Technical Service Bulletin

Bentayga Hybrid

2065926/5

Fuel pressure regulator - DTC P242200 with symptom code 14536 evident within address 0001

4M0 201 549A - Pressure regulator assembly and associated parts as shown below

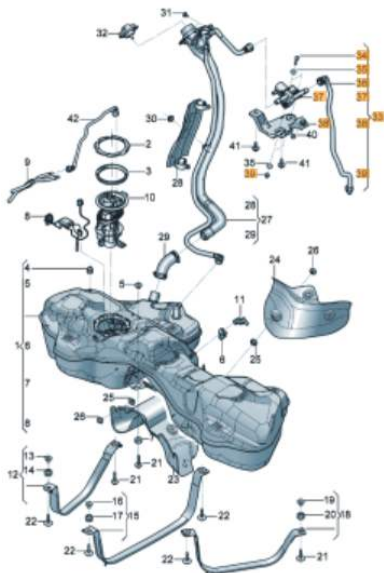
- 1) Referring to Rep.Gr 20 - Replace the Pressure regulator assembly and associated components
- 2) Conduct a road test in EV Mode and/or Hybrid drive mode where possible
- 3) On return from road test - Check to confirm the issue is resolved and DTC P242200 is not evident within address 0001

▶ 33	4M0 201 549 A	pressure regulator	
34	Oval hexagon socket head bolt	M6X30	Included in position: 33
35	Washer	M6	Included in position: 33
36	Breather line		Included in position: 33
37	pressure regulator		Included in position: 33
38	Bracket		Included in position: 33
39	Hexagon collar nut self-locking	M6	Included in position: 33
